Beechcraft

SERVICE INSTRUCTIONS

No. 0481-241
ATA Code 71-40

SUBJECT: POWER PLANT - ATTACH FITTINGS - MODIFICATION OF THROTTLE CONTROL INSTALLATION.

Figure 1. Installation of 169-910017-45 Throttle Control Bracket

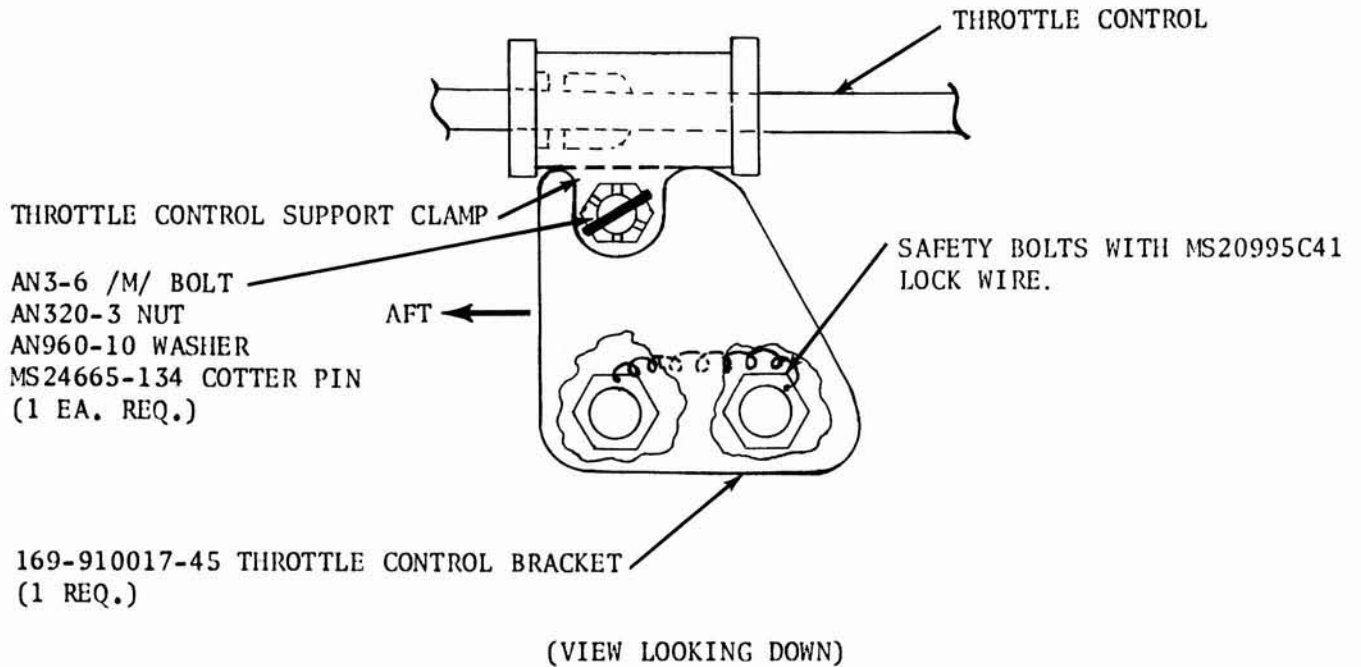
4. Remove the 169-910017-23 throttle control bracket on the bottom of the crankcase by removing the two bolts in the crankcase and the bolt securing the throttle control support clamp to the -23 bracket. Discard the -23 bracket and the attaching parts for the throttle control support clamp, but retain the attaching parts for the -23 bracket.

5. Replace the 169-910017-23 bracket with a 169-910017-45 bracket. (Refer to Figure 1.) Place the edge of the -45 bracket between the ears of the throttle control support clamp and secure the clamp to the -45 bracket with an AN3-6 /M/ bolt (head of bolt down), an AN320-3 nut, an AN960-10 washer, and an MS24665-134 cotter pin. Secure the -45 bracket to the bottom of the crankcase with the existing attaching parts, and safety the two attaching bolts with MS20995C41 lock wire.

Figure 2. Installation of 169-910017-49 Throttle Control Arm

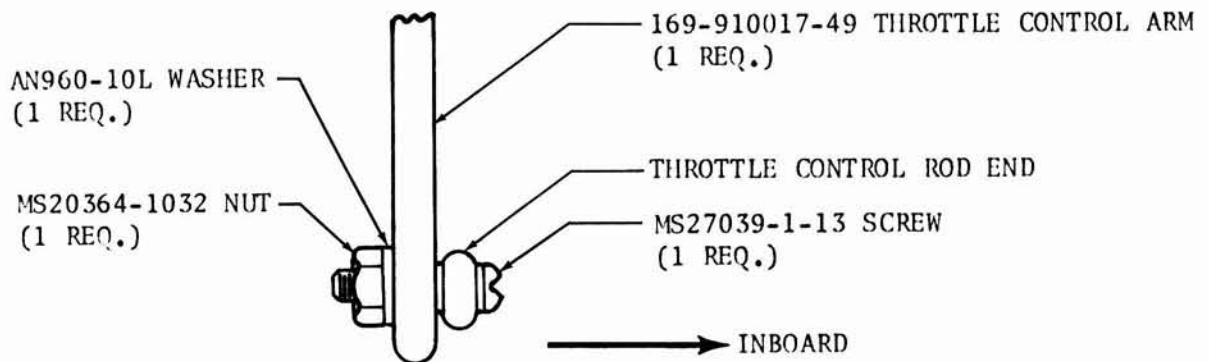
- Attach the throttle control rod end to the 169-910017-49 throttle control arm with an MS27039-1-13 screw, an MS20364-1032 nut, and an AN960-10L washer. (See Figure 2.)

Install the throttle control rod end and the head of the MS27039-1-13 screw on the inboard side of the 169-910017-49 throttle control arm as shown in Figure 2 to prevent possible interference with the landing gear warning horn switch bracket.
